Addendum No. 3 to IFB 21-41

To: All Parties on Record with the City of Somerville as Holding
IFB 21-41 Conway Park Remediation and Renovation Project

Re: Questions and Clarifications
Attachment: 1. Musco Pole Foundation Plans C1 and C2.

A **PIER DETAIL**
SCALE: NOT TO SCALE

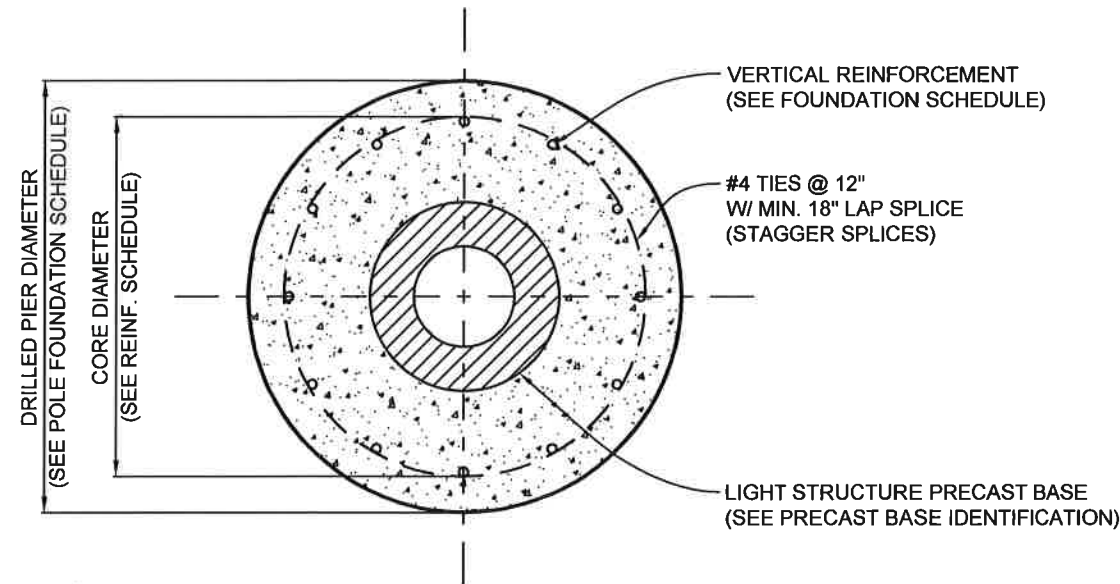
Question 46: Contract documents call out the Musco light system for the stadium lighting under this contract. Four poles will be 60' tall and 4 poles are to 70' tall. The detail on sheet E501 depicts a generic pole foundation standard for Musco supplied sports lighting yet there are no dimensions with respect to the depth of foundation and diameter. Contract specification section 26 56 58 – 6 calls for the design of the foundation drawings to be submitted at the time of bid to allow for accurate pricing. Please provide parameters to accurately price the foundation installation/excavation for the Musco lighting system (depth of foundation, diameter, and weight of precast foundation).

Response: Refer to attachment: Musco Pole and Foundation Plans C1 and C2 included herein.
